**Year 1 Monitoring Report**

**MATTHEW SITE**

NCDMS Project #100043 (Contract #7419)  
USACE Action ID: SAW-2017-00055  
DWR Project #2017-0624

Subject: Matthew MY1 Comments, Project ID #100043, DMS Contract #0007419

MY1 Matthew RL1-A Stage Recorder Hydrograph

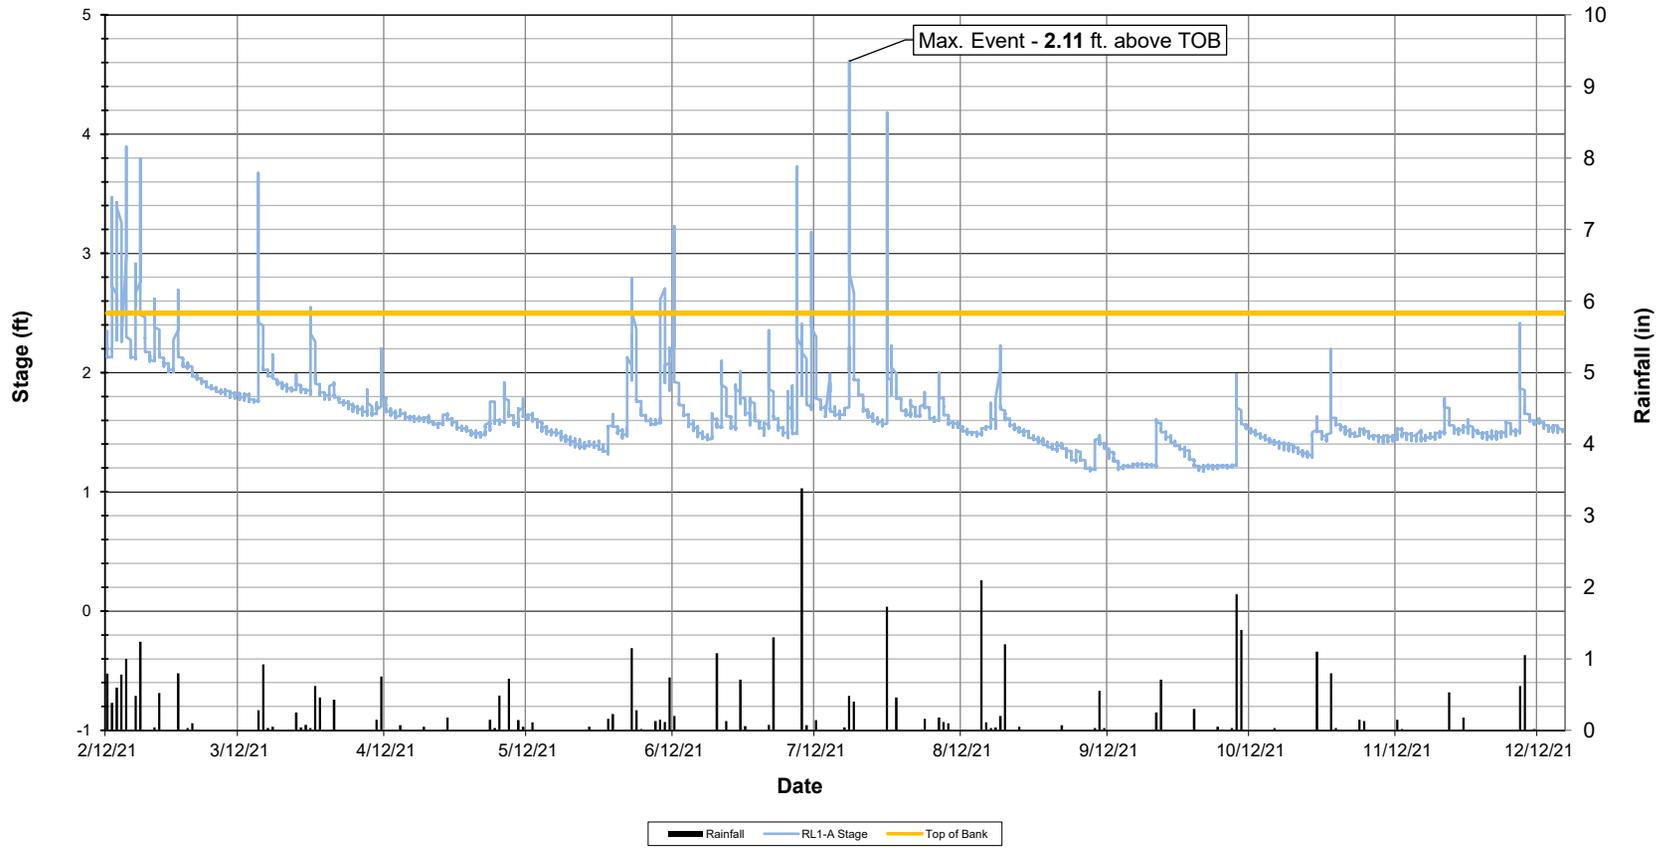
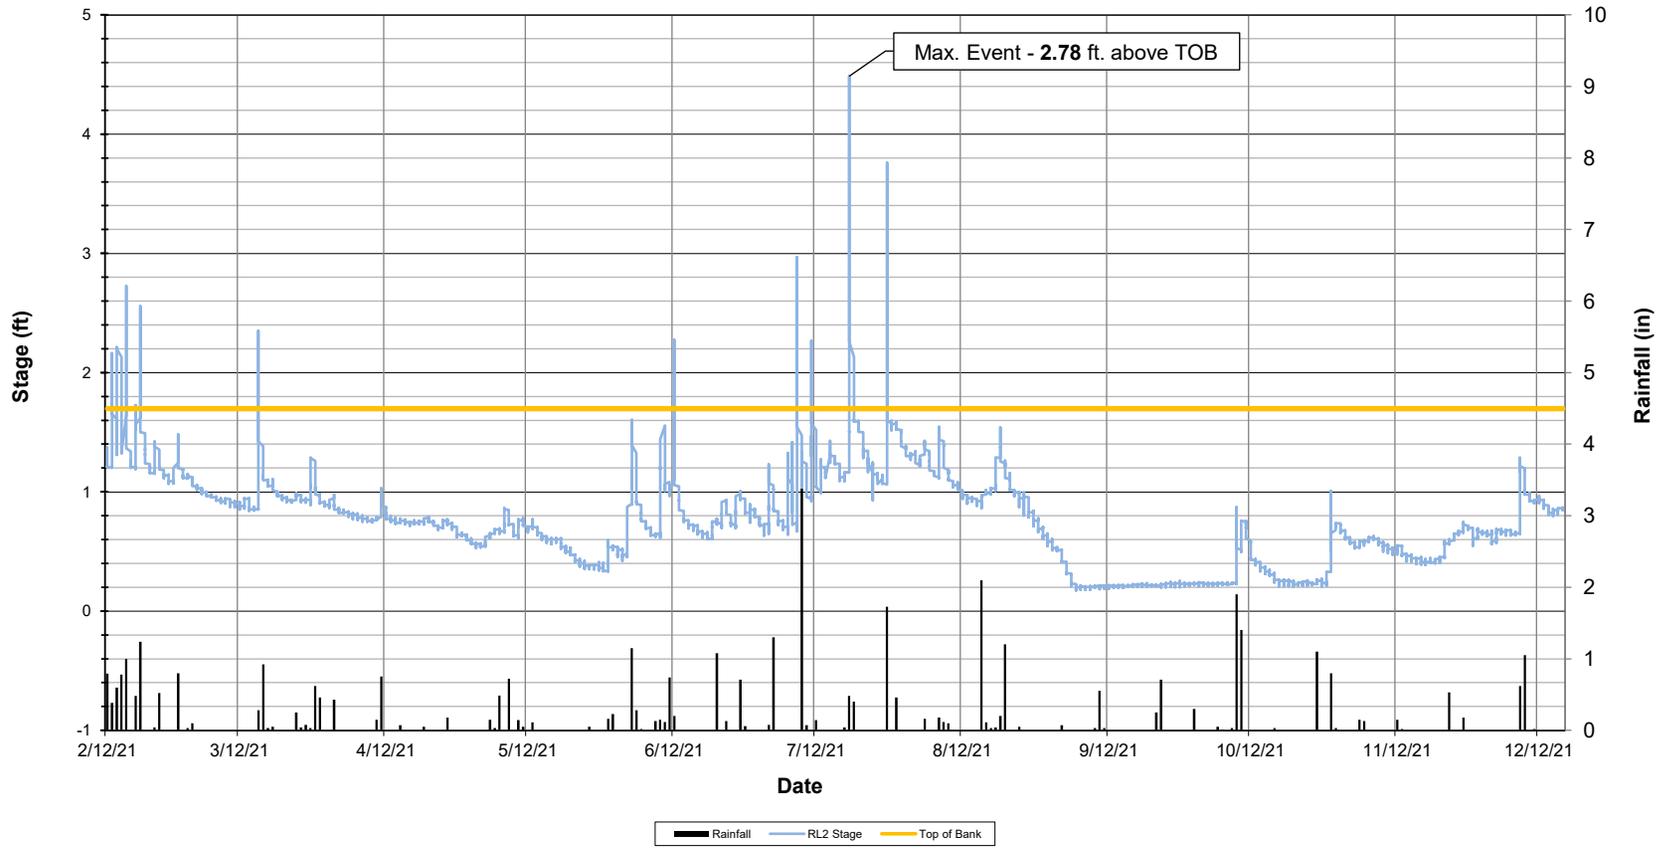
1. Please include figures displaying the stage recorder data for RL1-A and RL2.

1. Please include figures displaying the stage recorder data for RL1-A and RL2.

Stage recorder hydrographs have been created for both reaches. The charts/figures have been added to Appendix E. As for the electronic submission, the excel spreadsheet "MY1\_WellCharts\_2021" has been updated to include these as well (in folder 5).
